S.N.: 10/798,815
Art Unit: 2878

AMENDMENTS TO THE DRAWINGS:

REMARKS

FIG. 1A

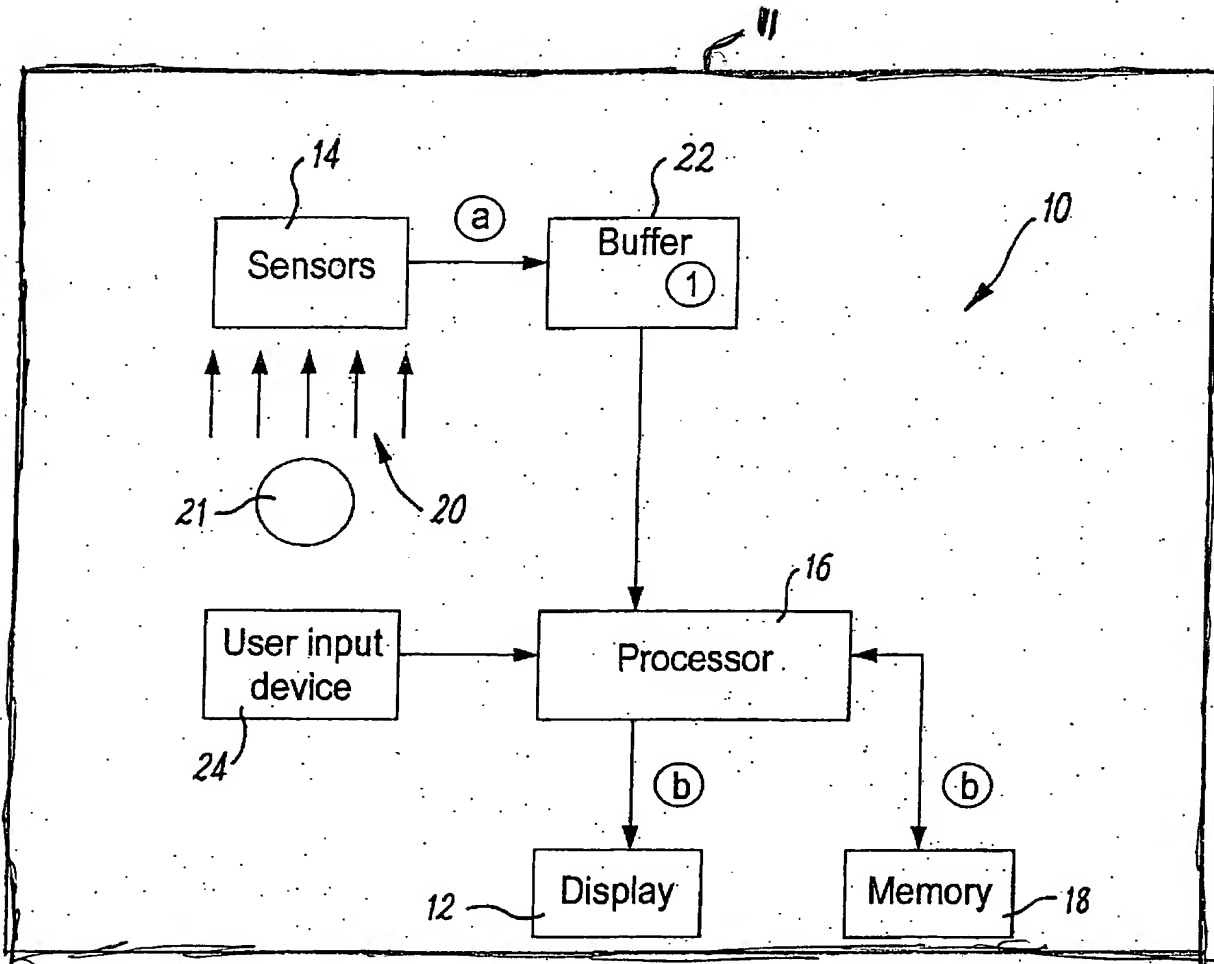
The attached sheet of drawings includes changes to Figs. 1A, 2A, and 3A, and replaces the original sheets of drawings corresponding to these figures. In Figs. 1A, 2A, and 3A, the previously omitted part number 11, referring to embodiments in which the systems 10 are incorporated into handheld devices 11, such as mobile phones, digital cameras, and PDAs, has been added.

The Patent Office objected to the drawings under 37 CFR 1.83(a). Replacement sheets are being provided in which system 10 is shown incorporated into a portable handheld device 11, which may be a digital camera, a mobile phone, or a PDA. Additionally, the specification, on page 5, lines 3-6, has been rearranged. It is respectfully submitted that no new matter has been added.
